**STAFF REPORT**

SUBJECT: Cole Valley Christian School – AZ, CUP  
[H-2023-0011](#)

Annexation and Zoning (AZ) of 71.28 acres of land with an R-15 (Medium High-Density Residential) zoning district; and Conditional Use Permit (CUP) for a private education institution for pre-kindergarten through 12th grade on 48.48 acres of land in the R-15 zoning district.

B. Proposed Site Plan with Phasing Plan (dated: 3/1/23)

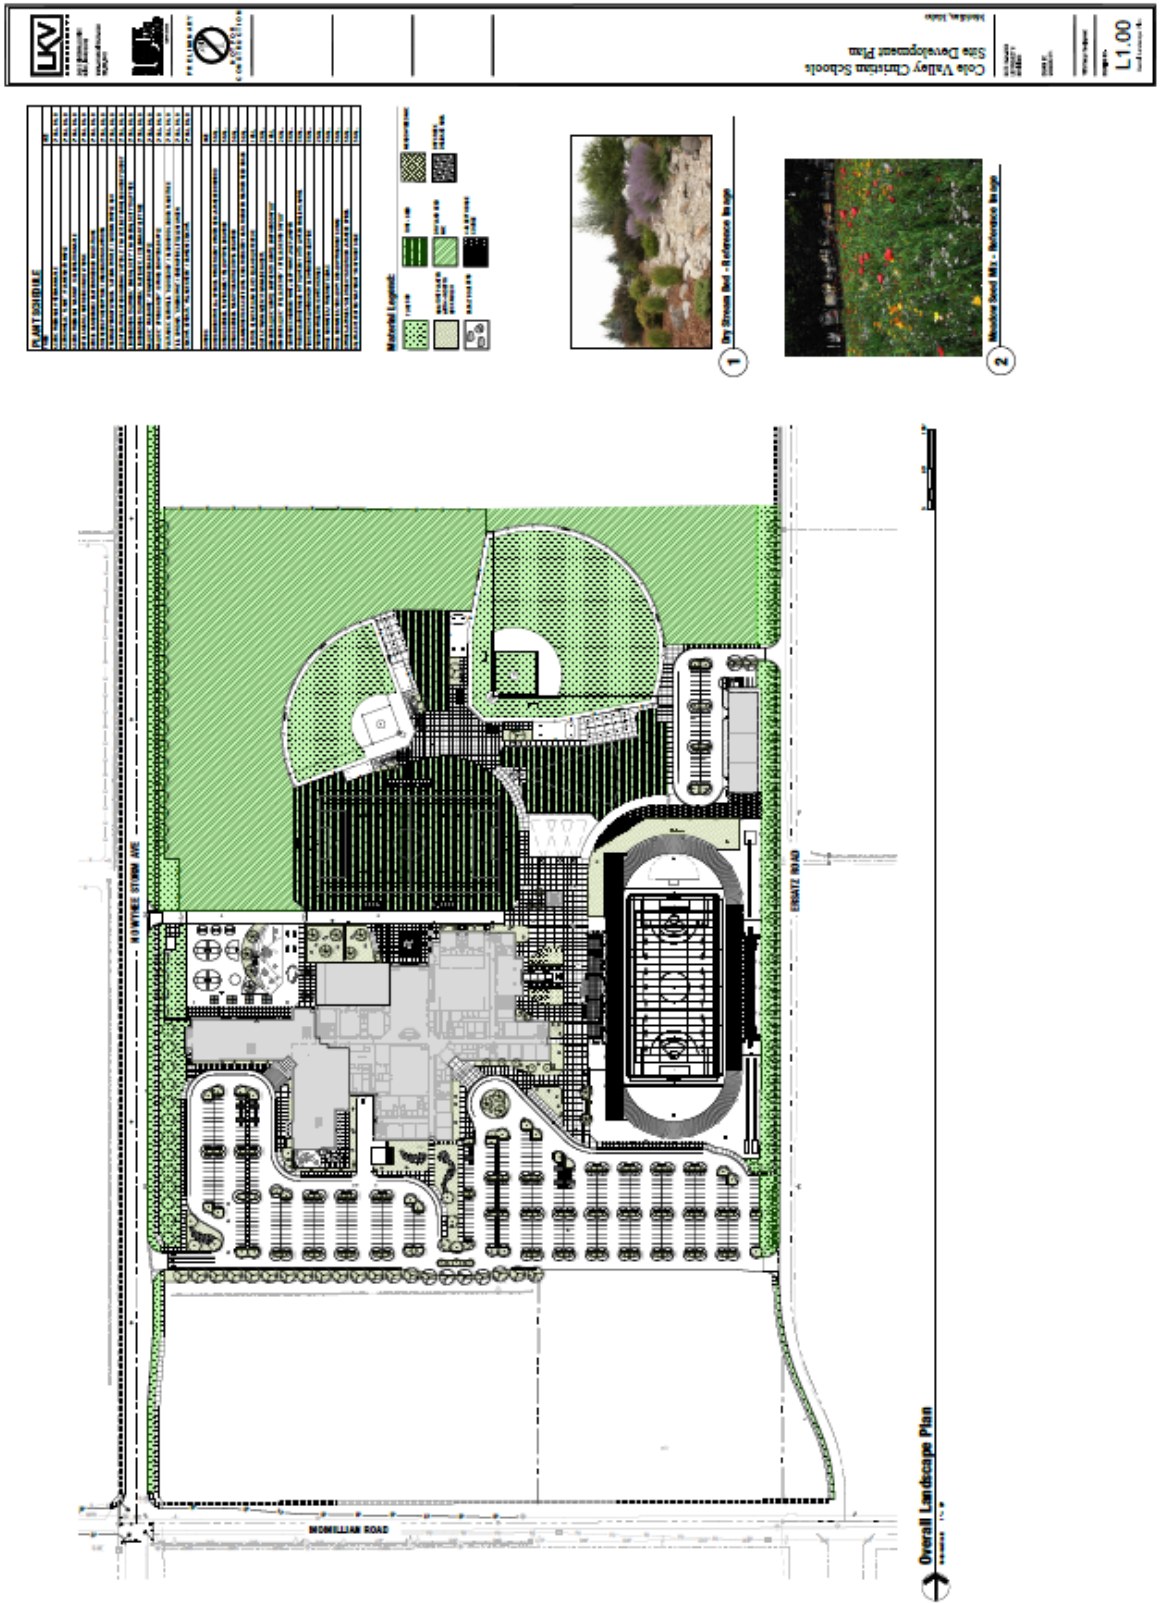
**Prior to City Council approval of the Development Agreement, an amended phasing plan shall be submitted that includes the extension of Owyhee Storm Ave. and Ersatz Place Road to the northern property boundary and detached sidewalks/multi-use pathways along McMillan Rd., Owyhee Storm Ave. and Ersatz Place Rd. with the first phase of development.**

C. Landscape Plan (dated: 3/1/23)

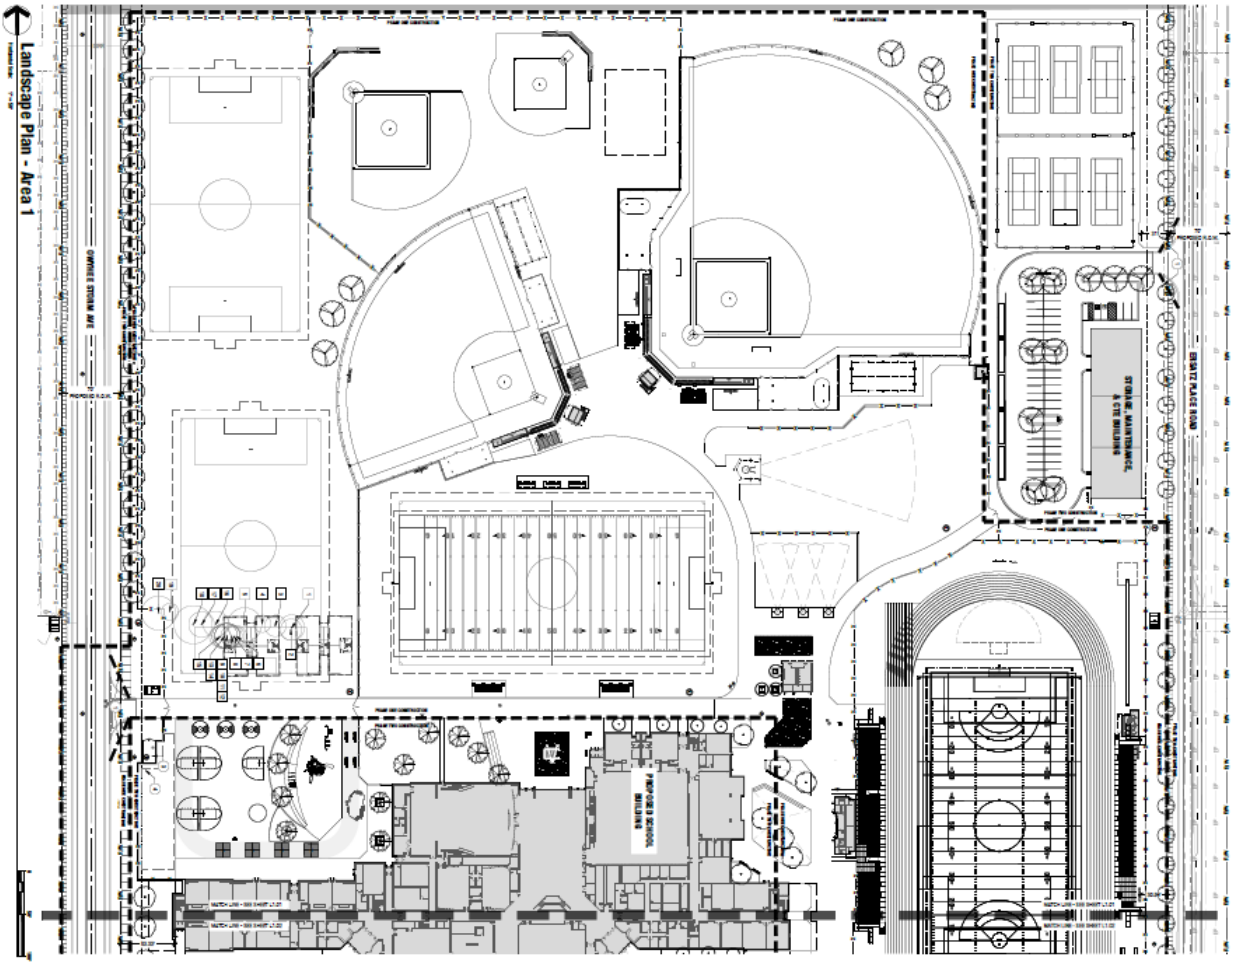
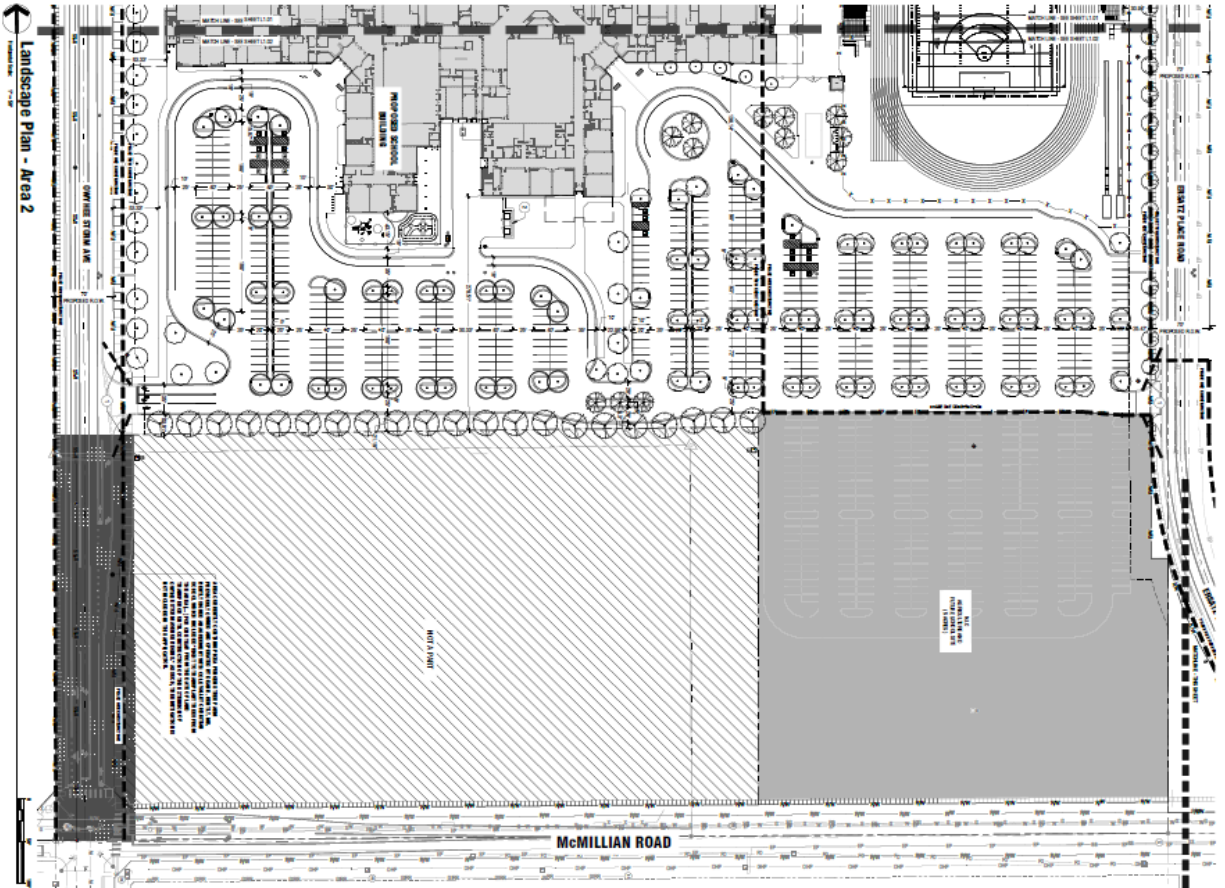
A minimum 25-foot wide street buffer is required along W. McMillan Rd., an arterial street and a minimum 20-foot wide street buffer is required along Owyhee Storm Ave., a collector street, landscaped in accord with the standards listed in UDC [11-3B-7C](#). **Buffers are required to be planted with a variety of trees, shrubs, lawn, or other vegetative groundcover. The landscape plan should be revised in accord with the aforementioned standards. Where the buffer is encumbered by an easement, the buffer area is required to include a minimum 5-foot wide area for planting shrubs and trees outside of the easement; the plans should be revised accordingly to accommodate the required plantings.**

**Waterways:** The West Tap Sublateral runs along the southern boundary of this site adjacent to McMillan Rd. and the Creason Lateral bisects this site within a 30-foot wide easement. **The UDC ([11-3A-6](#)) requires all waterways that lie on the property being developed to be piped or otherwise covered unless being improved as a water amenity of linear open space. The easement for the Creason Lateral shall be depicted on the site and landscape plans.**

- b. Depict landscaping within street buffers in accord with the standards listed in UDC [11-3B-7C.3](#), which requires a variety of trees, shrubs, lawn, or other vegetative groundcover among other specifications. *Where the buffer is encumbered by an easement, the buffer area shall include a minimum 5-foot wide area for planting shrubs and trees outside of the easement as set forth in UDC 11-3B-7C.1b.*
